Group:	61 – Cab & Body
Bulletin No.:	SB-14-001
Issue Date:	08/25/2014

SERVICE BULLETIN

In the event that a cracked or broken cab step exists on the driver's side or passenger side of the subject vehicles, a revised cab step has been released with a reinforcement pipe that will increase the robustness of the cab step to reduce the chance of repeated cracking or breaking. Vehicles built on or before January 18, 2013 will also require a reinforcement bolt be installed in the multi-layer steel flange on both sides of the vehicle.

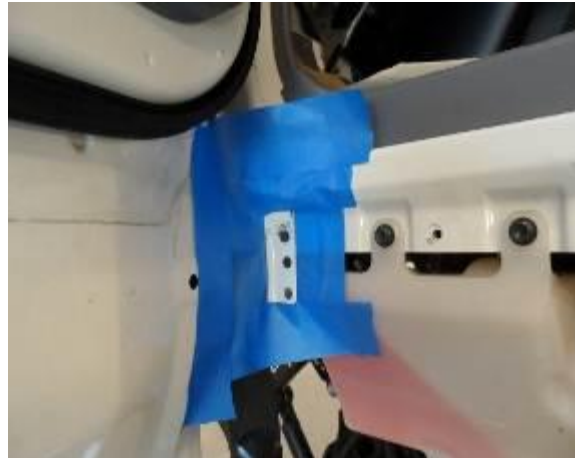
6. While looking under the driver's side of the cab, mark the 9mm hole to be drilled. The hole should be 18mm (3/4 inch) above the top hole in the lower flange. It should be 2mm to the right of the center of the 2 holes in the flange (on the edge of the ridge in the flange). See diagram below.

7. Using a 9mm (23/64th) drill bit, drill a hole through the multi-layer steel flange where the marking was made.

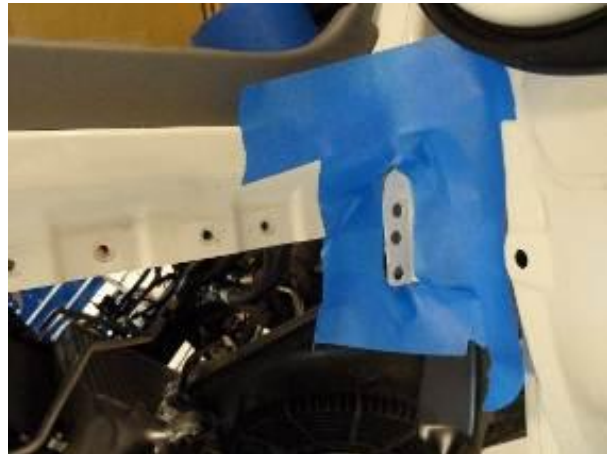
11. While looking under the passenger side of the cab, mark the 9mm hole to be drilled. The center of the hole should be 18mm (3/4 inch) above the center of the top hole in the lower flange. It should be 2mm to the left of the center of the 2 holes in the flange (on the edge of the ridge in the flange). See diagram below.

12. Using a 9mm (23/64th) drill bit, drill a hole through the multi-layer steel flange where the marking was made.

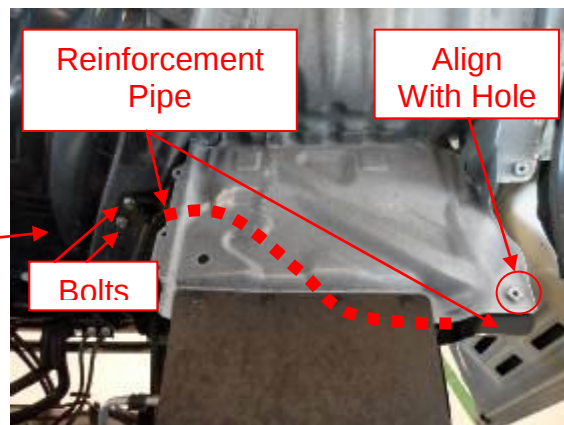
15. Install the passenger side reinforcement pipe (58307-37110) for the passenger side cab step using 2 bolts (91551-80820). Ensure the hole on the pipe is aligned with the welded nut located where the cab step attaches to the body. Tighten the 2 bolts to the specified torque.

Specified Torque: 23 lb-ft (31 Nm)

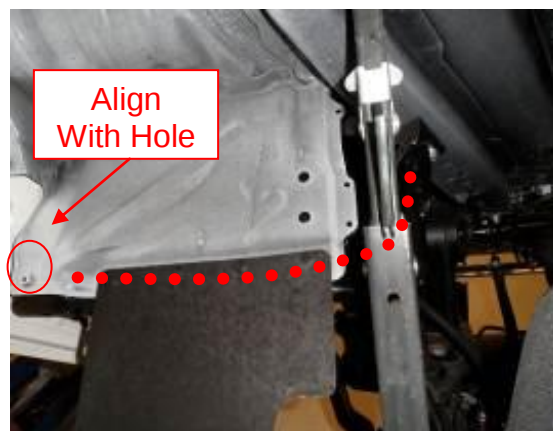
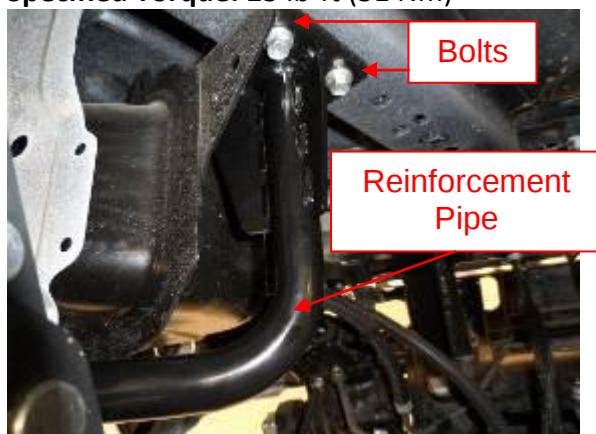
17. Install the driver's side reinforcement pipe (58308-37090) for the cab step. The pipe will be mounted in the same place from which the vacuum tank bolts were removed. Ensure the hole on the pipe is aligned with the welded nut located where the cab step attaches to the body. Tighten the 2 bolts to the specified torque.

Specified Torque: 23 lb-ft (31 Nm)

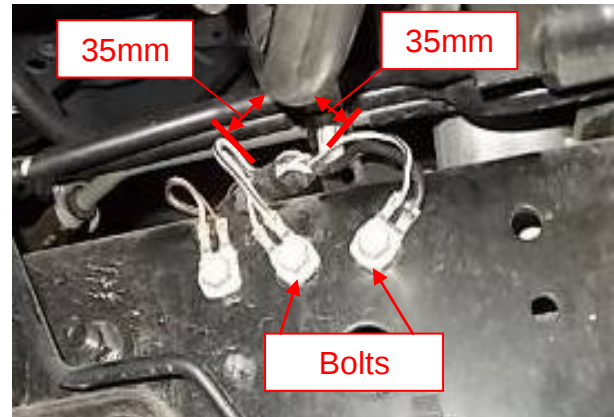
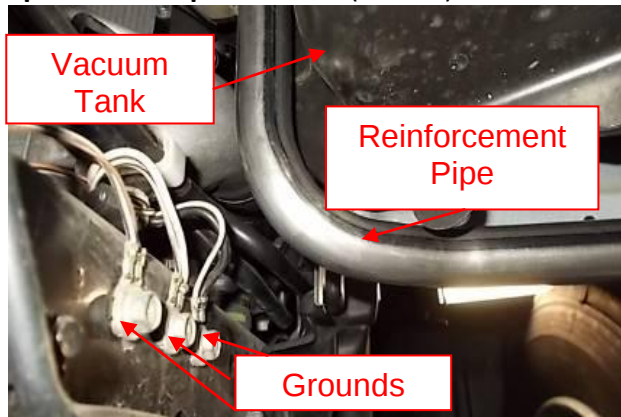
18. Locate the ground wires on the driver's side frame rail. The ground wires will need to be repositioned to allow for 35mm of clearance between the new reinforcement pipe and the chassis grounds. Loosen the 2 ground bolts; reposition the wires as needed, then torque the ground bolts to the specified torque.

Specified Torque: 13 lb-ft (18 Nm)

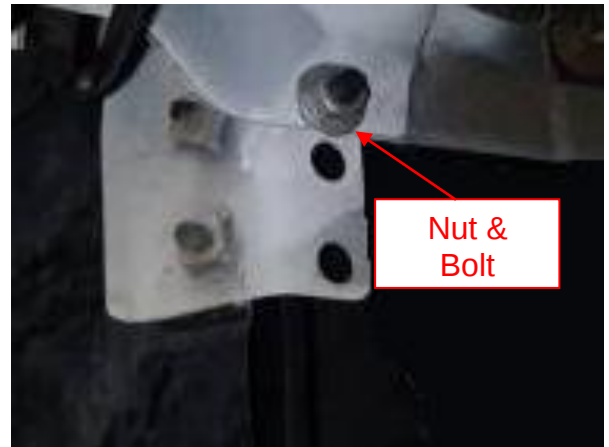
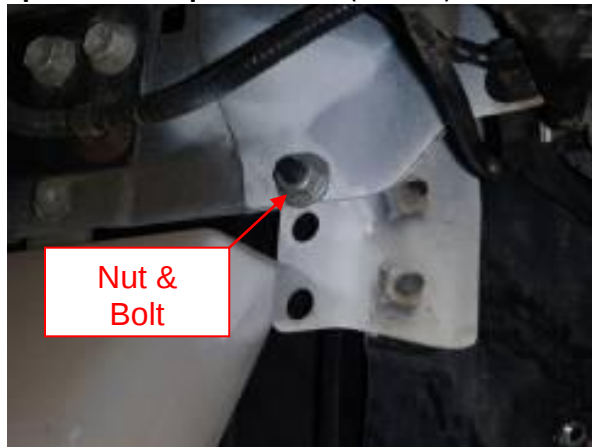
19. Once the paint has dried, install a bolt (90109-08295) through the flange on each side. Install a nut (90179-08184) on the back side of the flange. Tighten the nut to the specified torque.

Specified Torque: 20 lb-ft (27 Nm)

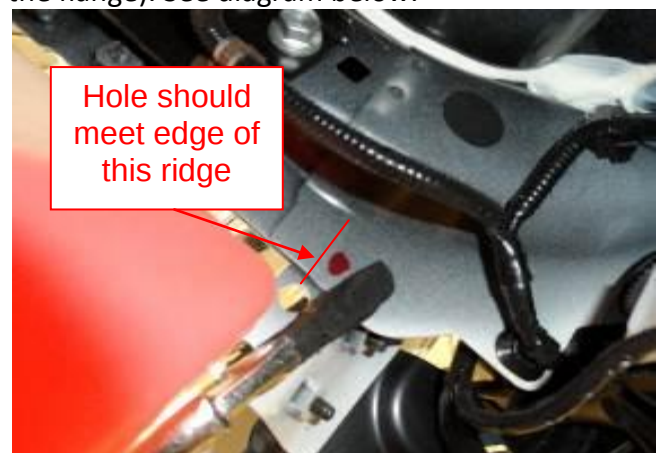
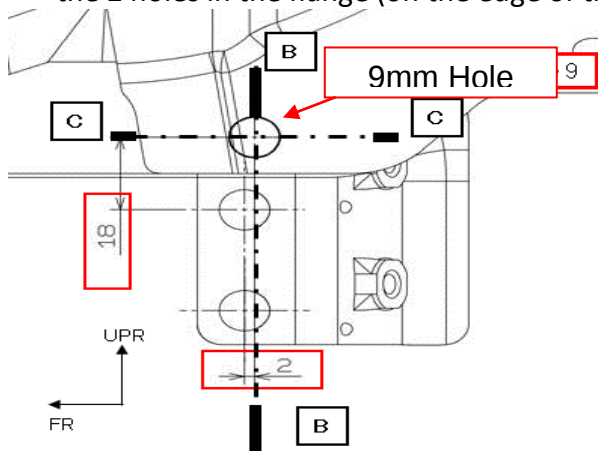
- While looking under the driver's side of the cab, mark the 9mm hole to be drilled. The hole should be 18mm (3/4 inch) above the top hole in the lower flange. It should be 2mm to the right of the center of the 2 holes in the flange (on the edge of the ridge in the flange). See diagram below.

6. Using a 9mm (23/64th) drill bit, drill a hole through the multi-layer steel flange where the marking was made.

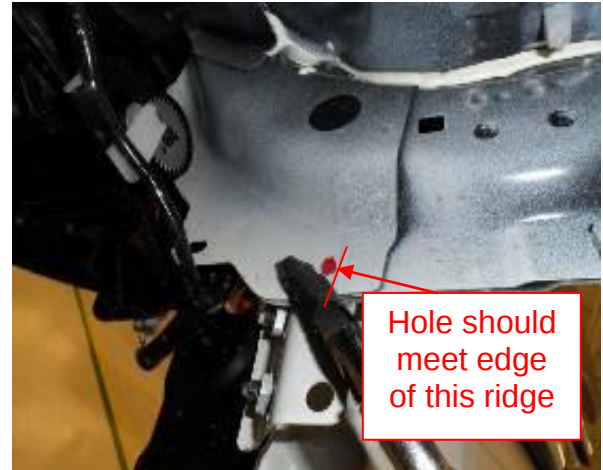
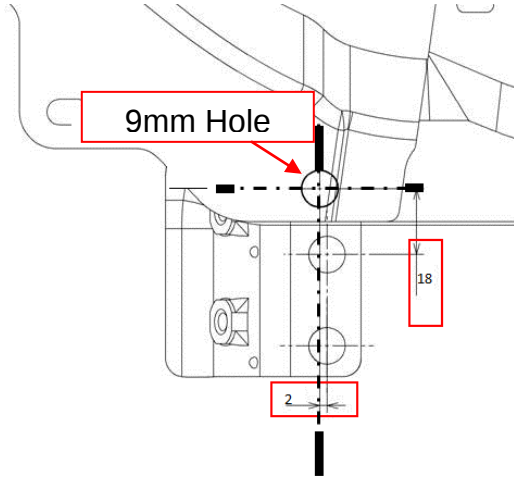
14. While looking under the passenger side of the cab, mark the 9mm hole to be drilled. The center of the hole should be 18mm (3/4 inch) above the center of the top hole in the lower flange. It should be 2mm to the left of the center of the 2 holes in the flange (on the edge of the ridge in the flange). See diagram below.

15. Using a 9mm (23/64th) drill bit, drill a hole through the multi-layer steel flange where the marking was made.

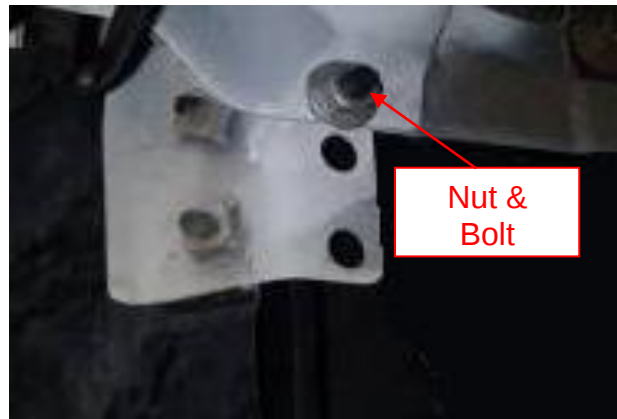
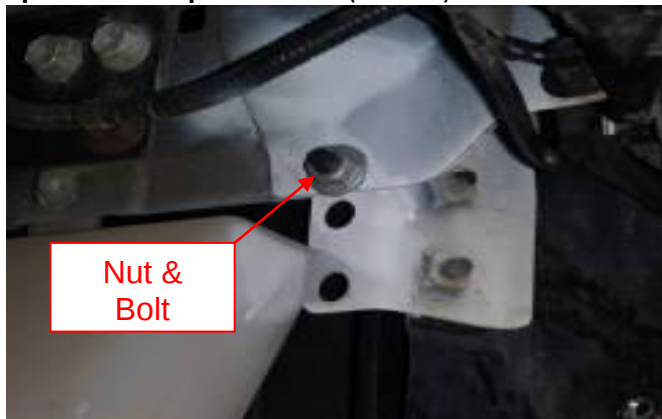
25. Once the paint has dried, remove the masking tape. Install a bolt (90109-08295) through the flange on each side. Install a nut (90179-08184) on the back side of the flange. Tighten the nut to the specified torque.

Specified Torque: 20 lb-ft (27 Nm)
